MONTGOMERY COUNTY PLANNING DEPARTMENT
THE MARYLAND-NATIONAL CAPITAL PARK AND PLANNING COMMISSION

MEMORANDUM

PROJECT: Cedar Lane Bridge (No. M-0074) over Rock Creek
CIP No. 509132-05

REVIEW TYPE: Mandatory Referral No. MR2010802

PROPOSED CEDAR LANE

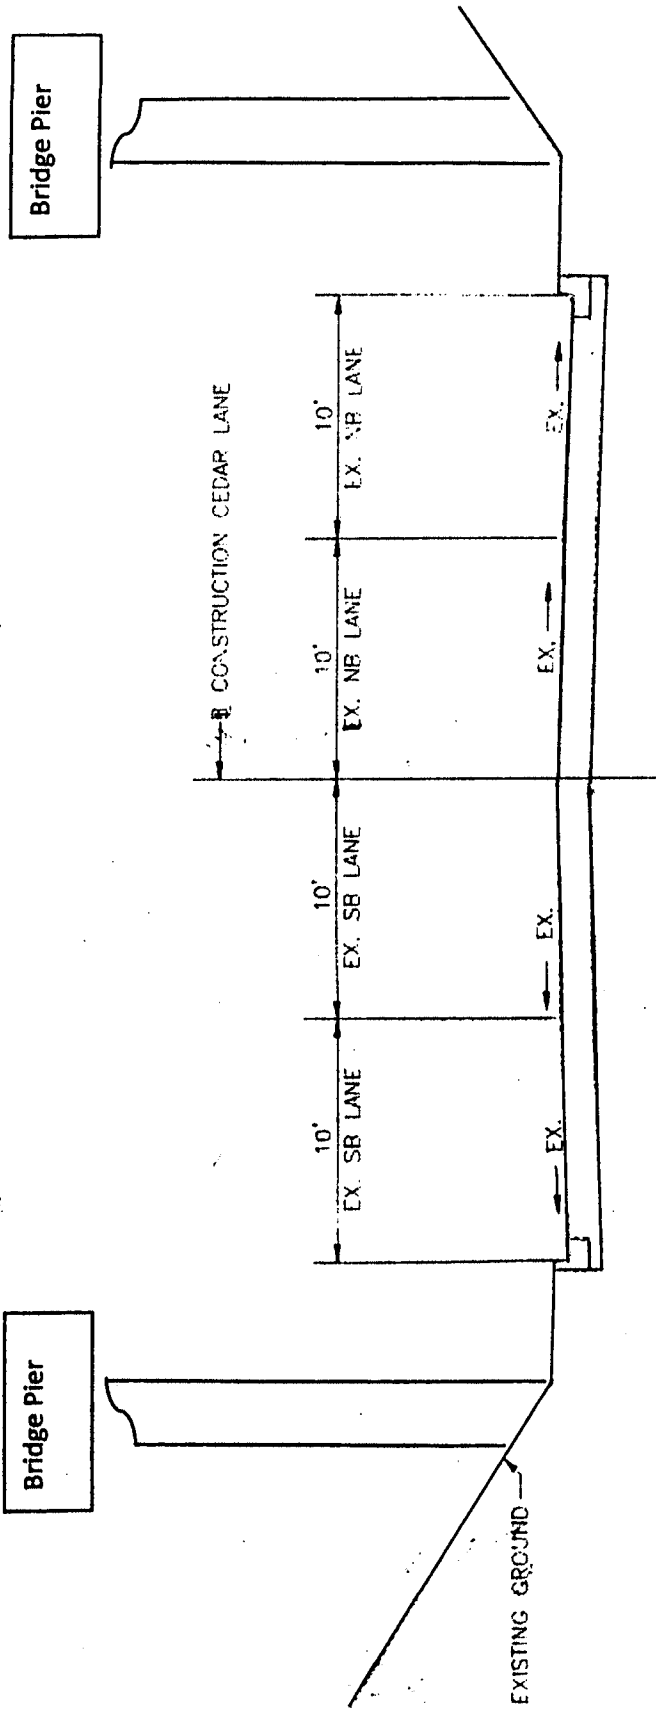
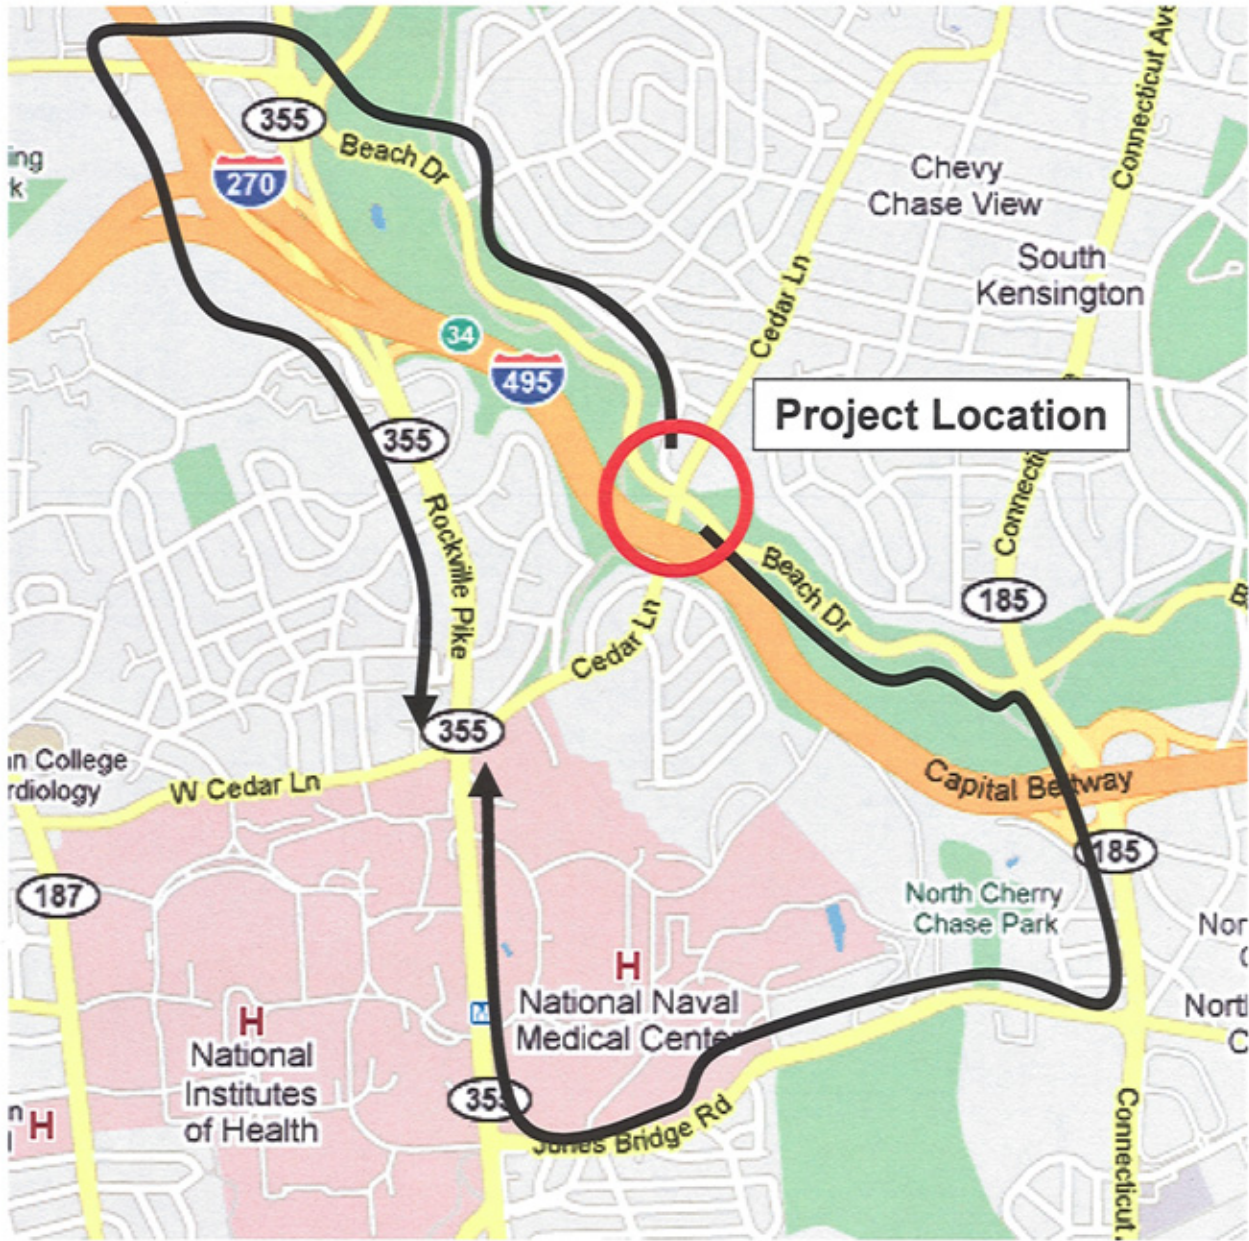
To gain the space needed for the path, MCDOT proposes to reduce the number of southbound travel lanes from two to one. At the April, 14, 2010 public meeting sponsored by MCDOT, some

Residents at the 4/14/10 meeting were also concerned that the plans did not include a southbound left turn lane to East Parkhill Drive and that backups would result from a single vehicle waiting to turn left. In a discussion with MCDOT and their consultants after the meeting, it was determined that a left turn lane could be provided. We recommend that this be done.

The proposed roadway section does not conform to the road standards recently approved as Executive Regulations as a follow-up to the Road Code update, as discussed above, but we believe that it is an appropriate response to competing demands from the various modes of traffic.

Staff recommended improvements of park trail from MD355 to Cedar Lane at Capital Beltway

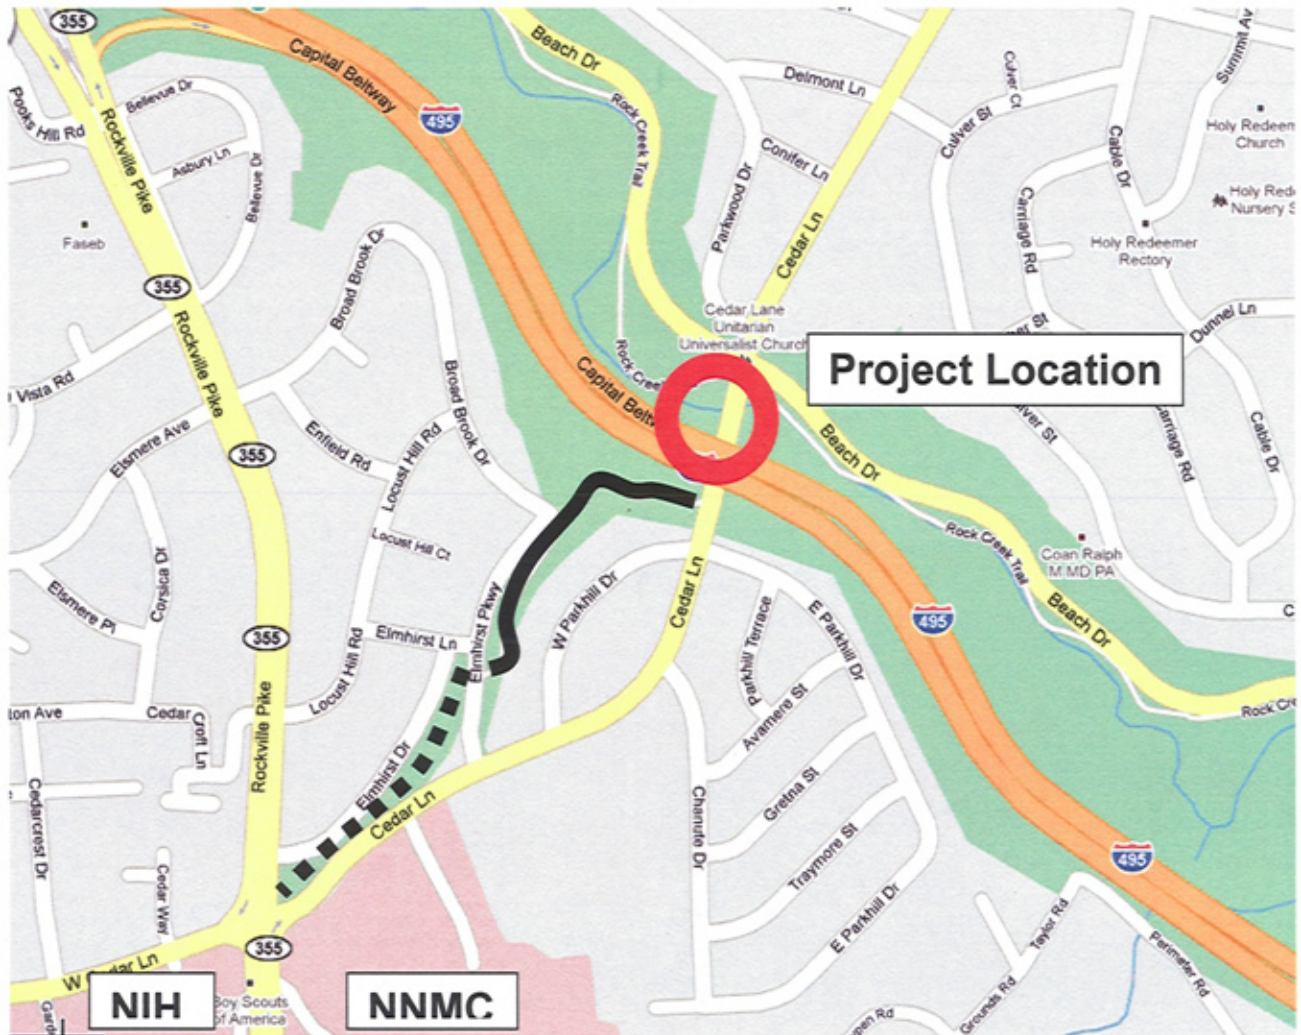
One speaker at the 4/14/10 meeting asked MCDOT to widen the Elmhirst Parkway trail from its current six feet to improve bicyclist accommodation. MCDOT staff in turn asked us to construct the widening. Parks staff agrees that the widening is desirable but recommends that it be done by MCDOT as part of this project, although we can assist them in preparing the environmental documentation and addressing park permit issues.

Attachment 5 shows the park trail that begins at MD355, runs along the north side of Cedar Lane, crosses Elmhirst Parkway, runs along the east side of Elmhirst Parkway, then turns east to tie into Cedar Lane. The segment from MD355 to Elmhirst Parkway is also on park property and has been recommended by staff to be improved by SHA as mitigation for park impacts resulting from their MD355/Cedar Lane BRAC intersection project, which is currently scheduled to be reviewed by the Board as a Mandatory Referral on July 22, 2010. The segment from Elmhirst Parkway to Cedar Lane that we're recommending be improved by MCDOT as part of the subject

- Elmhurst Parkway to Cedar Lane**
 (recommended to be included in MCDOT's Cedar Lane Bridge project)
- MD355 to Elmhurst Parkway** (recommended to be done as part of the park mitigation for SHA's MD355/Cedar Lane intersection project)
